Intersection ID: 19485	Main Street: MONIQUE_LN	Cross Street: PARK_RD	Location:	SE
ADA ID: 39997A809A09	Ramp Type: PerpDiag	Initial Pass/Fail: Fail	Overall Compliance: No	Severity Score: 12.5

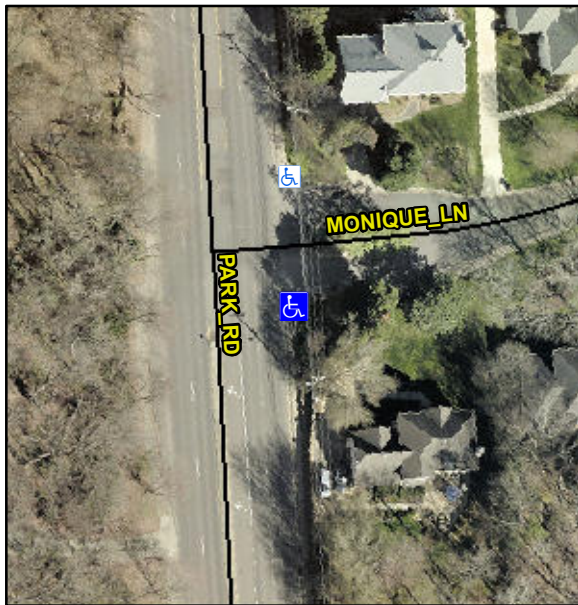
Not Found, R304.2.2

Compliance	Description	Data	Compliance	Description	Data
N/A	Ramp Length (in)	61.0	No	Ramp Slope (%)	8.8
Yes	Ramp Width (in)	48.0	Yes	Ramp XSlope (%)	0.8
N/A	Flare Type LT	N/A	N/A	Flare Type RT	N/A
N/A	Flare Slope LT (%)	N/A	N/A	Flare Slope RT (%)	N/A
N/A	Flare Traversable LT?	N/A	N/A	Flare Traversable RT?	N/A
N/A	Landing Length (in)	N/A	N/A	DWS Provided?	N/A
N/A	Landing Width (in)	N/A	N/A	DWS Contrast?	N/A
N/A	Landing Slope (%)	N/A	N/A	DWS Length (in)	N/A
N/A	Landing X Slope (%)	N/A	N/A	DWS Full Width?	N/A
N/A	Landing Curb? (Y/N)	N/A	N/A	DWS Offset (in)	N/A
N/A	Shared Landing?	N/A			
N/A	Gutter Ponding?	N/A	N/A	Gutter Slope (%)	N/A
N/A	Gutter Lip Ht (in)	N/A	N/A	Gutter X Slope (%)	N/A
N/A	Painted X Walk1?	No	N/A	Painted X Walk2?	No
	X Walk 1 Direction	To N		X Walk 2 Direction	To W
N/A	X Walk 1 Width (in)	N/A	N/A	X Walk 2 Width (in)	N/A
	X Walk 1 Slope (%)	2.9		X Walk 2 Slope (%)	2.6
	X Walk 1 X Slope (%)	3.0		X Walk 2 X Slope (%)	3.6

Remove & Replace Curb Ramp With Two New Directional Ramps or Equivalent.
